Indiana Michigan
Power Company
Nuclear Generation Group
One Cook Place
Bridgman, MI 49106
aep.com

AEP-NRC-2020-01
10 CFR 50.90

Docket No.: 50-315

Donald C. Cook Nuclear Plant Unit 1
License Amendment Request Regarding a Change to the Reactor Coolant System Pressure and
Temperature Limits and Low Temperature Overpressure Protection (LTOP) System

Figure 3.4.3-1 (page 1 of 1)
 Reactor Coolant System Pressure versus Temperature Limits -
 Heatup Limit, Criticality Limit, and Leak Test Limit
 (Applicable for service period up to 3248 EFPY and during vacuum fill)

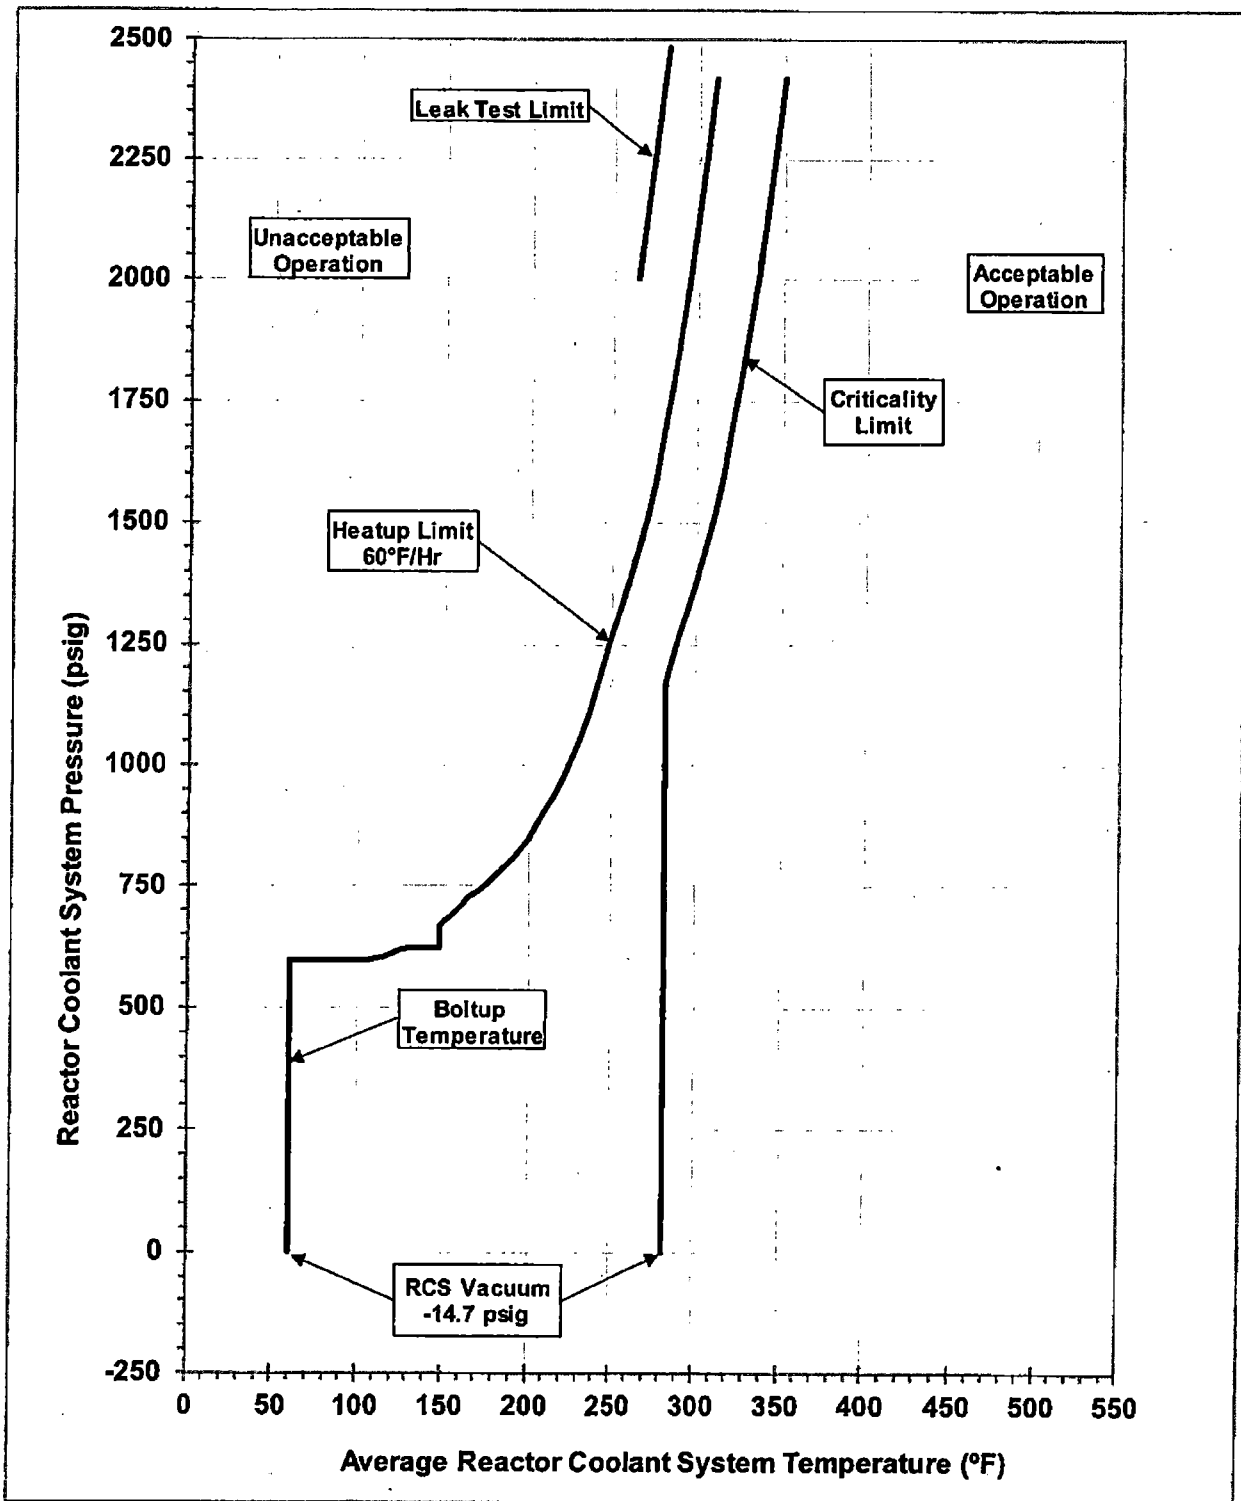
As expected, the revised curves are more restrictive in some operating regions than the existing ones, due to the effects of increased neutron fluence over the life of the reactor vessel, and the associated increase in RT_{NDT} at the $\frac{1}{4}$ thickness (1/4T) and $\frac{3}{4}$ thickness (3/4T) locations. Although the revised curves are more restrictive in some operating regions, the current technical specifications are conservative for today's operation and will be from now until the amendment is approved. This would include TS 3.4.6 Note 2 and the 152°F limit on RCP operation. The new curves were developed using the standard Westinghouse methodologies which have been previously reviewed and approved by the NRC for other licensees.

- a. Replace the existing TS Figure 3.4.3-1 and Figure 3.4.3-2 with the proposed TS Figure 3.4.3-1 and Figure 3.4.3-2 as shown in Enclosure 3.

This change replaces the CNP Unit 1 RCS P/T curves applicable up to 32 EFY with curves applicable up to 48 EFY and reflects the analysis in Enclosure 5 to this letter.
